PROJECT: GRANITE FALLS 2 SOUTH

CITY OF LAS VEGAS		DATE:
INTER-OFFICE MEMORANDUM		June 11, 2014
TO: Land Development Services Department of Building & Safety		FROM: Albert Sung, P.E. Flood Control Project Engineer Department of Public Works
SUBJECT:	Drainage Study for:	COPIES TO:
	Granite Falls 2 South	Slater Hanifan Group
Cross Streets:	NWC of Iron Mountain Road & Bradley Road	Verlaine LLC / Richmond American
File Number:	F:\Depot\DSMemos\DS4663B.doc	Bart Anderson, P.E., DevCo
Parcel Number:	125-01-402-009 to 125-01-402-016	
Zoning Action:	GPA-52122; ZON-52123; VAC-52125 & TMP-52127	
FEMA Flood Zone	YES	NO X
Proposed Storm Drain	YES	NO X

TECHNICAL DRAINAGE STUDY
ADDENDUM #1

Granite Falls 2 South
City of Las Vegas, Nevada

PLAN AND PROFILE - 12-INCH PVC SD BLEEDER

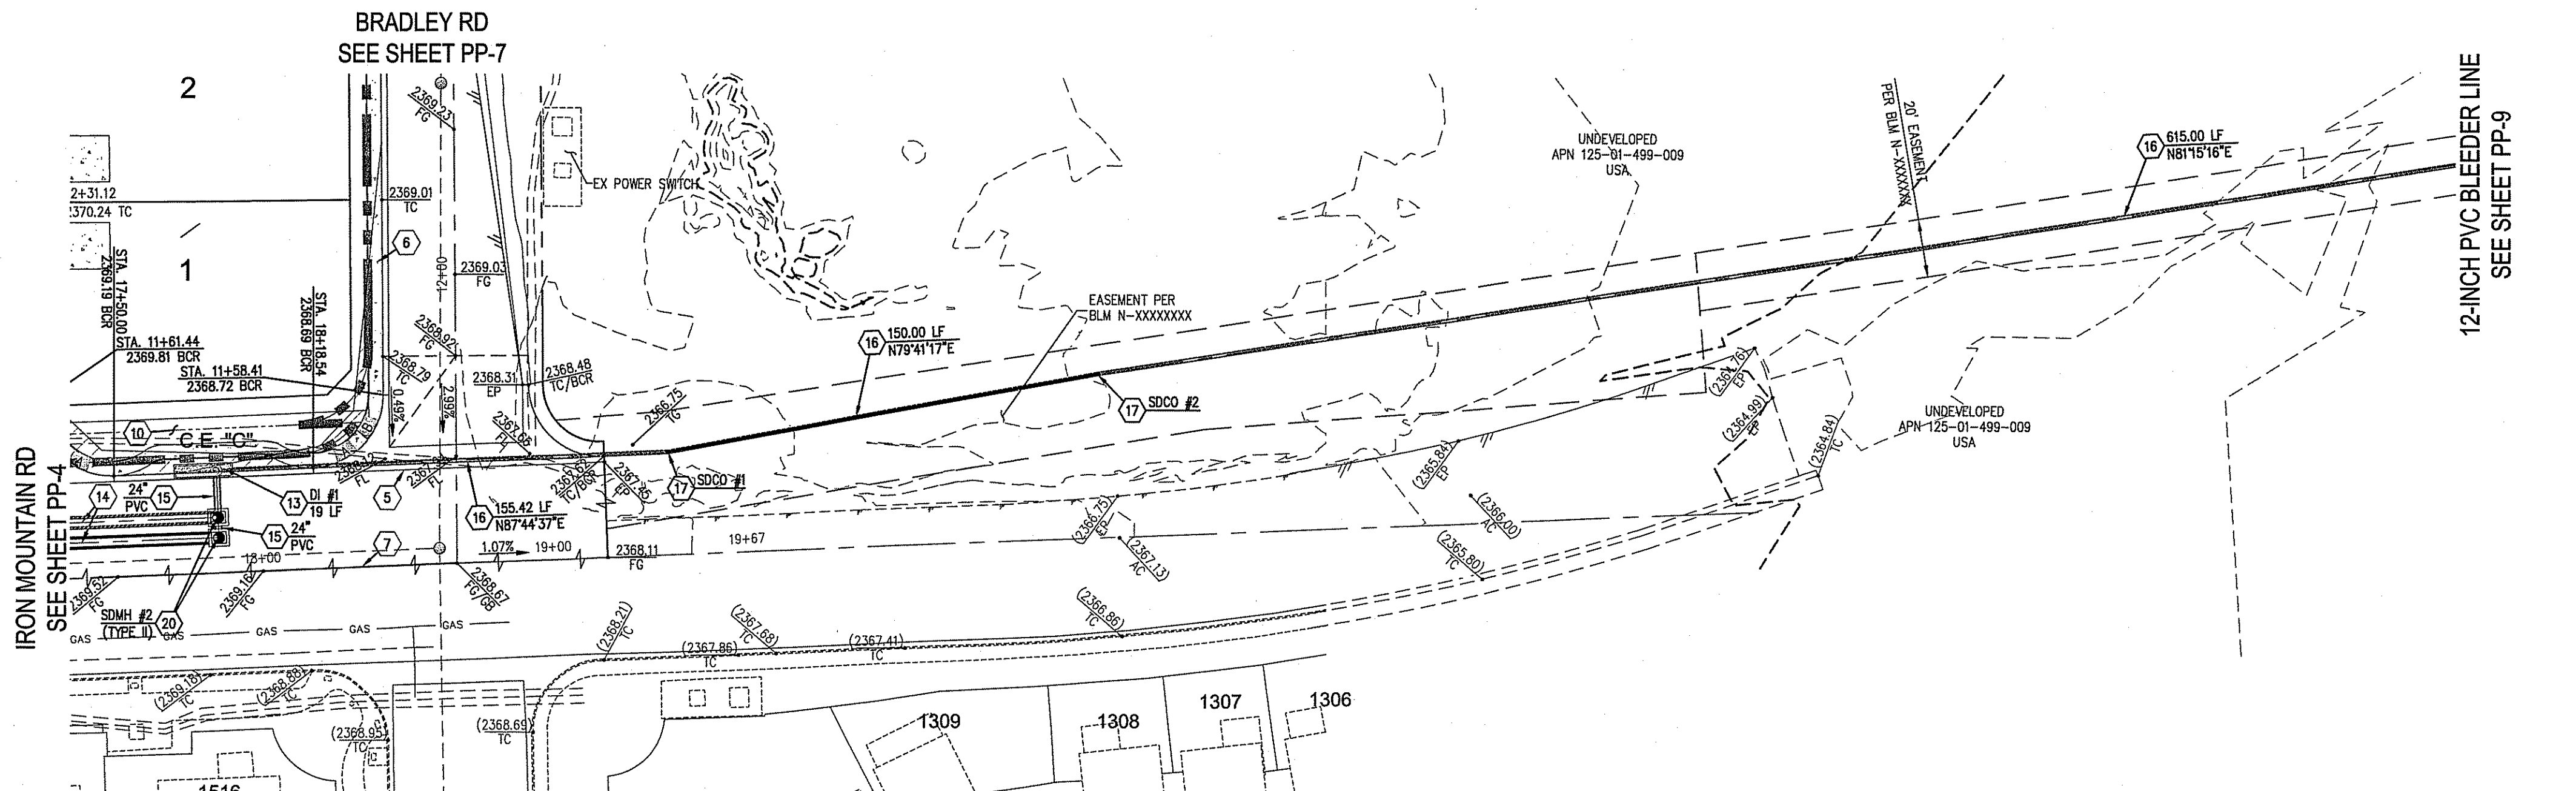
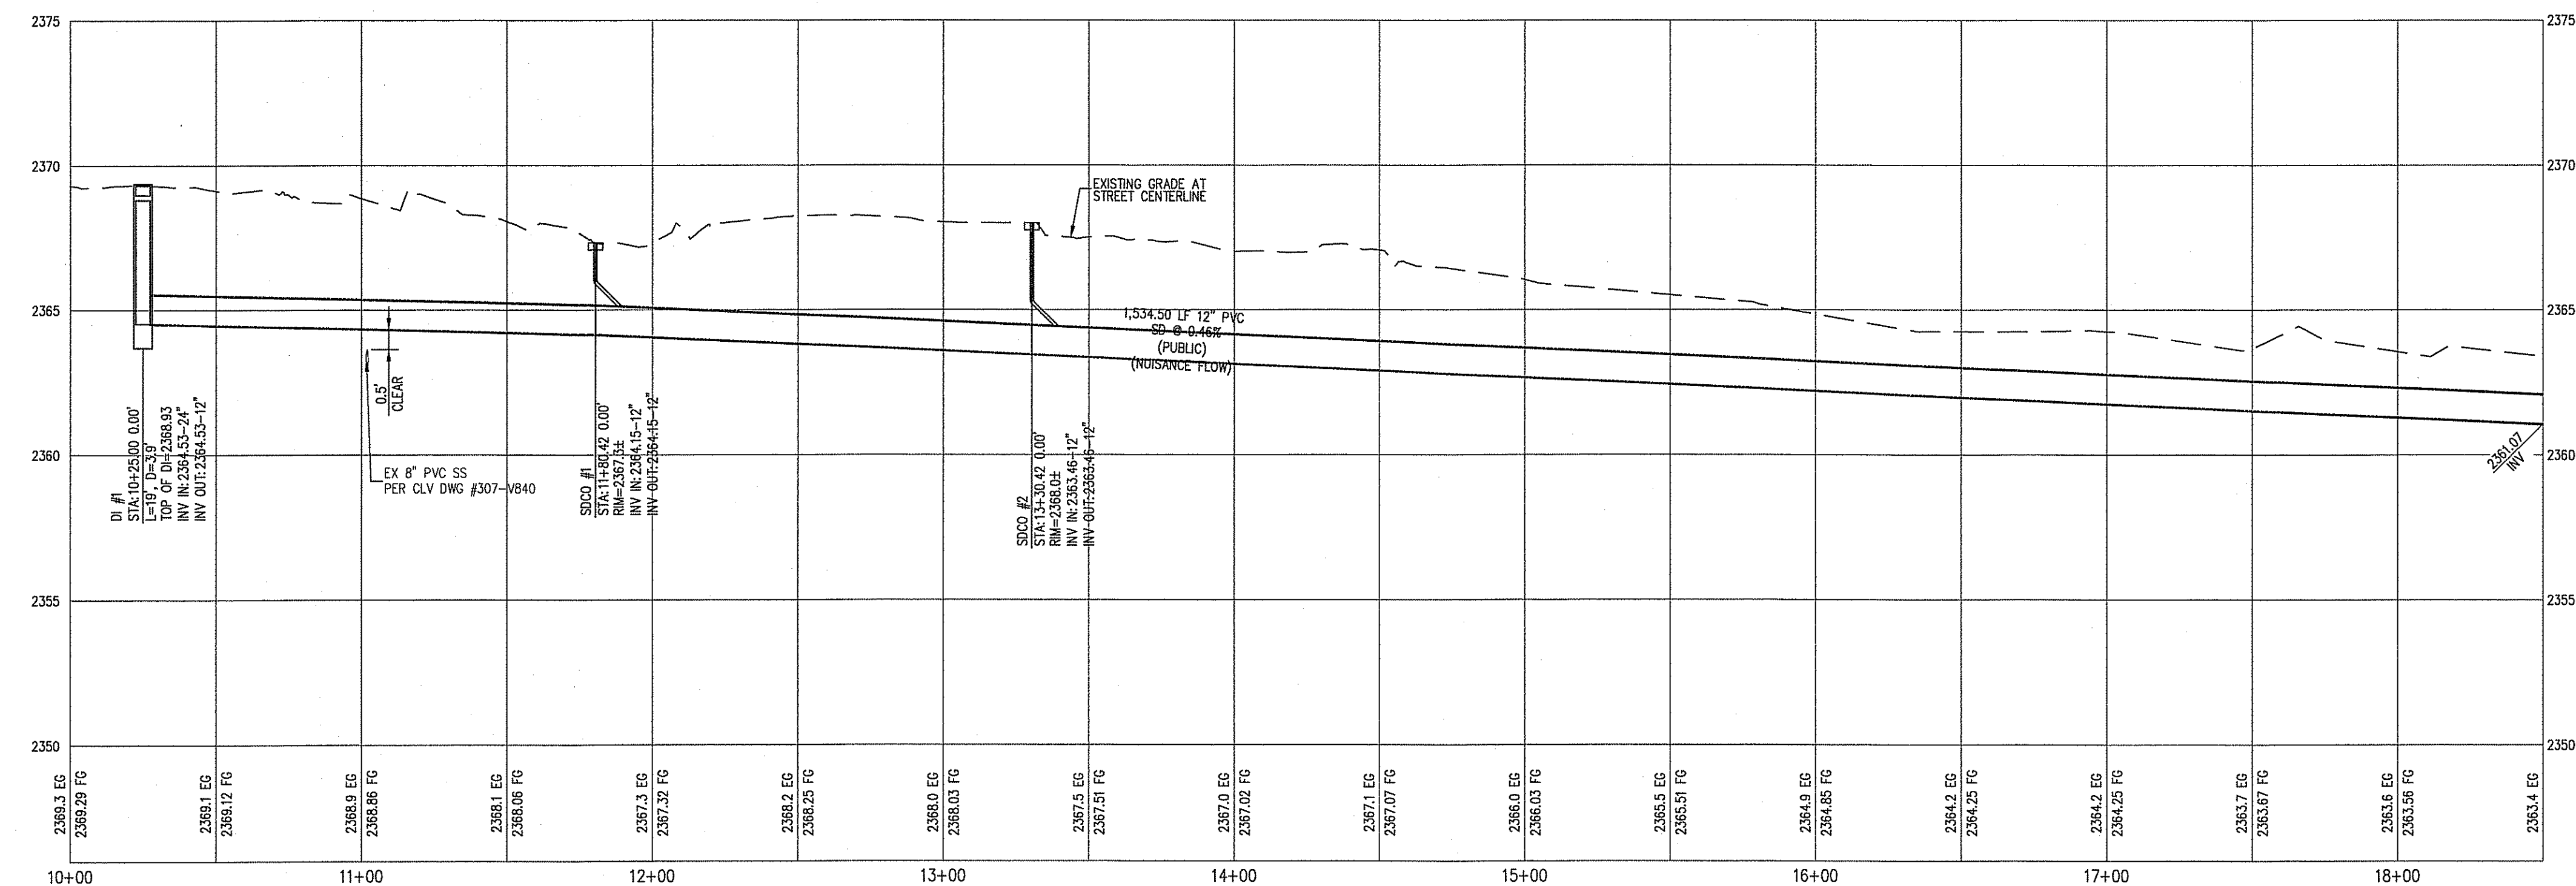
- The proposed bubbler and the bleeder line encroach into the property of the *Bureau of Land Management* (BLM). Drainage easement grant must be obtained from the BLM prior to the final approval of the improvement plans.

2. **Comment:** *The proposed bubbler and the bleeder line encroach into the property of the Bureau of Land Management (BLM). Drainage easement grant must be obtained from the BLM prior to the final approval of the improvement plans.*

Response: Acknowledged, the BLM grant for the adjacent property will be provided upon receipt.

Per the above mentioned meeting with City of Las Vegas, the 12-inch bleeder line provided for positive drainage of nuisance flow has been revised to include clean outs per CLV's request. See Appendix E for pertinent profiles.

SECTION HNY2 DEVELOPED (100-YR)

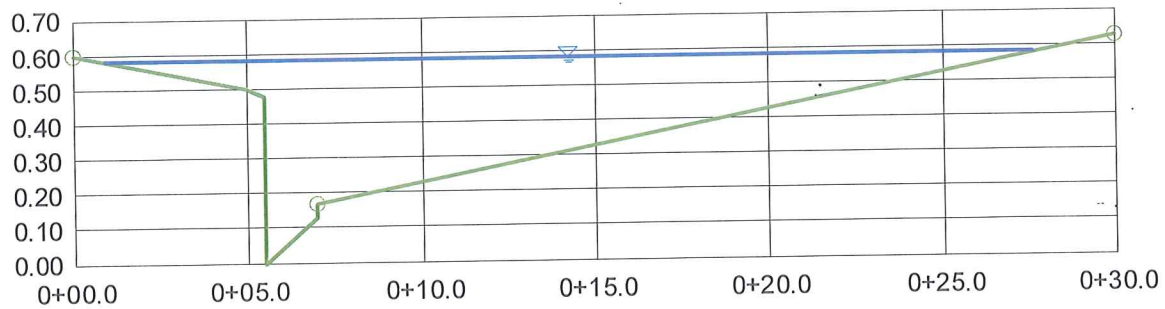
4. **Comment:** *The proposed hump in the west driveway entrance off of Honey Creek Avenue does not provide enough freeboard for 100-year storm event protection. The hump has to provide a minimum freeboard of six inches above the anticipated 100-year storm water surface in the corresponding street elevation. Review and revise accordingly.*

4. The proposed hump in the west driveway entrance off of Honey Creek Avenue does not provide enough freeboard for 100-year storm event protection. The hump has to provide a minimum freeboard of six inches above the anticipated 100-year storm water surface in the corresponding street elevation. Review and revise accordingly.

- The proposed high point at the Saxon Canyon Street entry from Honey Creek Avenue, has been elevated approximately 0.1-ft above the 100-year flow depth produced by Section HNY2. The high point perpetuates Honey Creek flows east without causing any impact to proposed lots from offsite flows. However, since the CCRFCD required 6-inches of freeboard above the 100-year flow depth is not provided in Saxon Canyon, an assessment of the offsite flow thru the site has been performed to show that the affected finished floors remain adequately elevated above the resulting overflow depth. Note that the developed condition (19 cfs) generates the highest flow rate that can overflow thru the site at Section HNY2, because during the ultimate condition (24 cfs) it is anticipated that half of the flow is

Project Description	
Worksheet	SECTION IRN0 ULTIMATE (10-YR)
Flow Element	Irregular Channel
Method	Manning's Formula
Solve For	Channel Depth

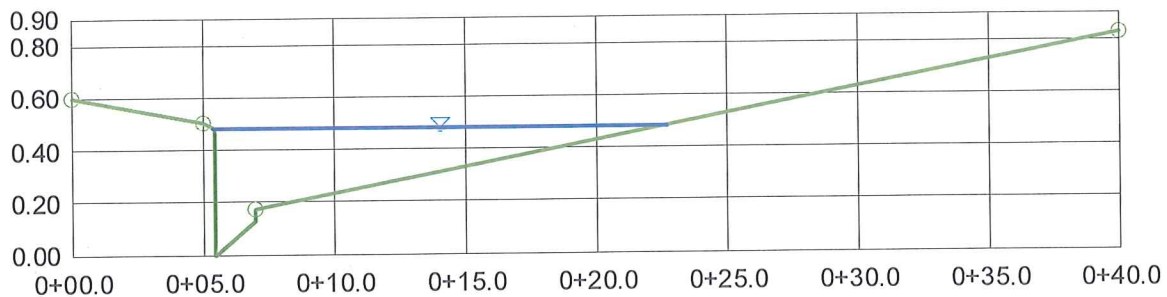
- Iron Mountain street section IRN0 has been provided to validate the necessity of a 5-ft Type C drop inlet to meet street flow criteria after flow contribution from Pauley Hills Street. The Iron Mountain Road storm drain profile has been revised and reflects the addition this drop inlet. Refer to Appendix C for supporting computations. See "Additional Revision 2" in this report to further elaborate on storm drain revisions.

* 5-ft DI PROVIDED TO COLLECT FLOW AND MEET DRY LANE CRITERIA.
